# SERVICE

NUMBER 42

# BULLETIN

**SUBJECT:** Elevator Bungee Installation

NEW BUNGEE INSTALLATION

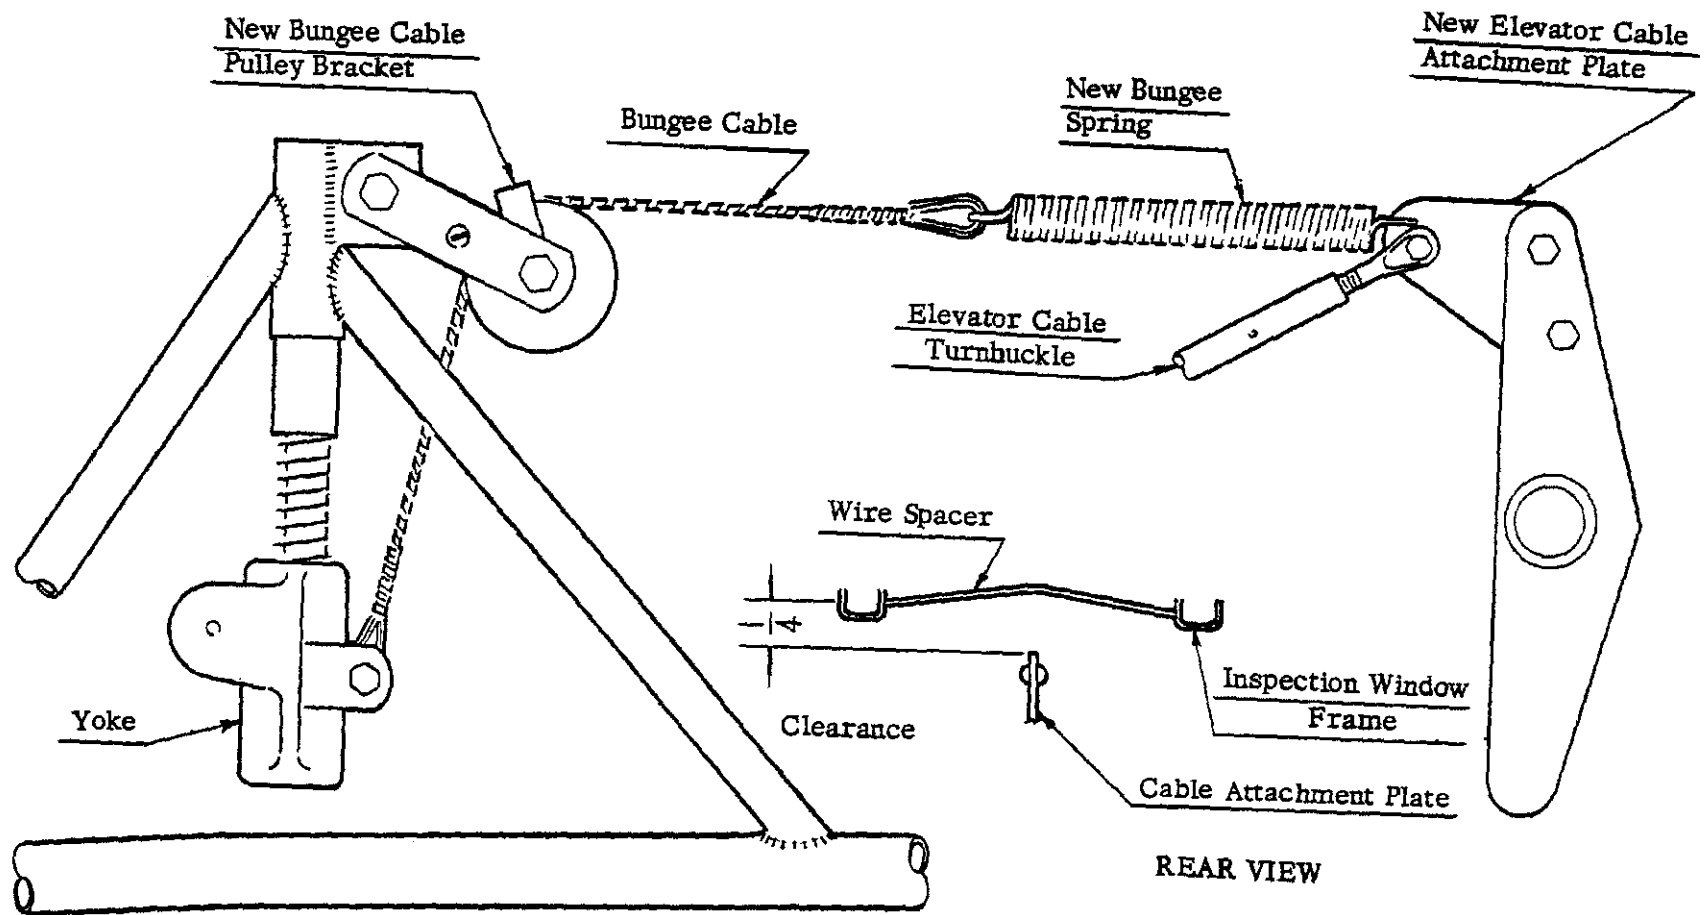
1. The Bungee cable pulley bracket, elevator cable to horn attachment plate and Bungee spring must be replaced by the parts accompanying this bulletin.

2. From the accompanying sketch it will be noted that the revised installation is similar to the original one with the exception of the above mentioned parts and the fact that the spring now attaches directly to a small hole in the elevator cable attachment plate. The small plate, washer and No. 4 screw and nut, that were used to attach the original spring, may be discarded. In dis-assembling the installation, it will not be necessary to disconnect the forward end of the Bungee cable from the stabilizer yoke and in reassembling the installation, the new spring and elevator cable link should be attached to the Bungee cable, then the new pulley bracket and pulley should be installed. The elevator cable plate should then be bolted between the elevator horns and lastly the elevator cable turnbuckle attached to this plate, making certain the turnbuckle is free to swivel.

In the fuselage structure, directly above the elevator horn, there is a wire spacer between the inspection window channels. This should be bent up in the center, if necessary, to prevent interference with the enlarged cable attachment plate. A 1/4" clearance at this point, when the elevator horn is in the most critical position, is considered satisfactory.
